RE: DOE Dockets: PP-398; DOE EIS 499
PUC Dockets: 14-21; 12-1163
Scoping Comments – Environmental Review
Not-So-Great Northern Transmission Line

I am submitting these comments for Residents and Ratepayers Against Not-so-Great Northern Transmission (RRANT).

Figure E-2: Northern Area Study Transmission Options

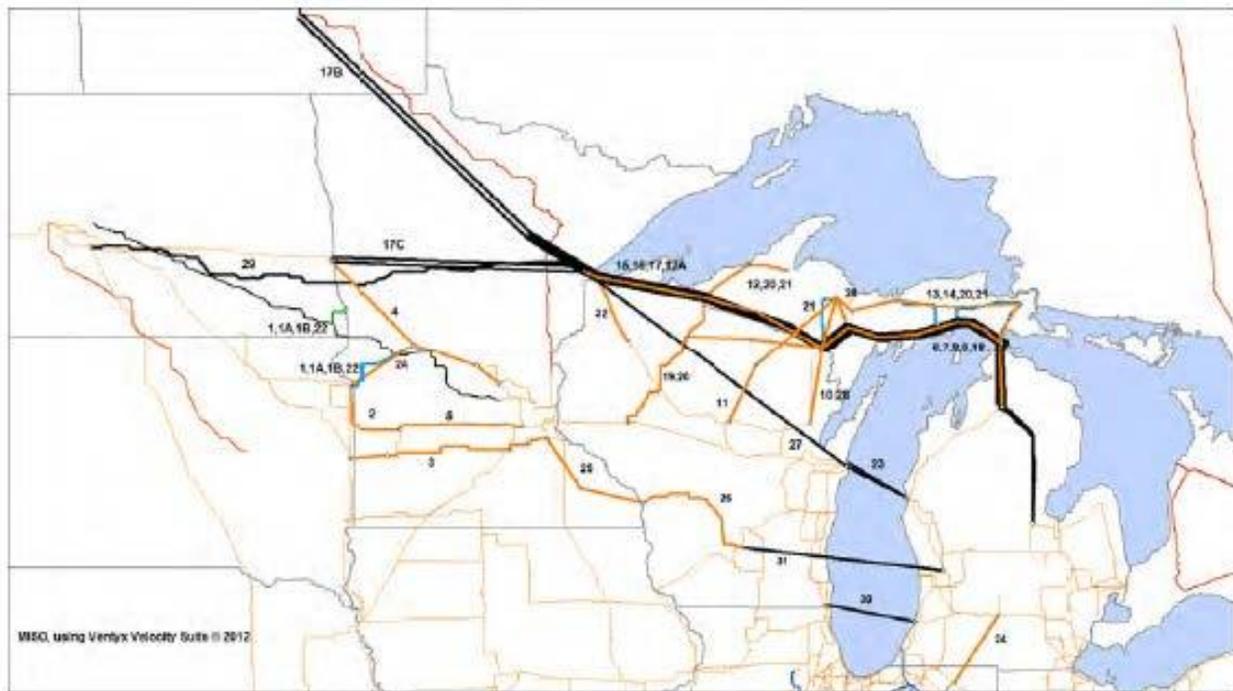
The EIS must also consider impacts of the whole project heading eastward. Will it function electrically if it ends at the Blackberry Substation, as this application states? Will it need the “Phase II” segment from Blackberry to Arrowhead to function? Will it need to go over the U.P. across the bridge and down towards Detroit to achieve the “benefits” claimed in this application?
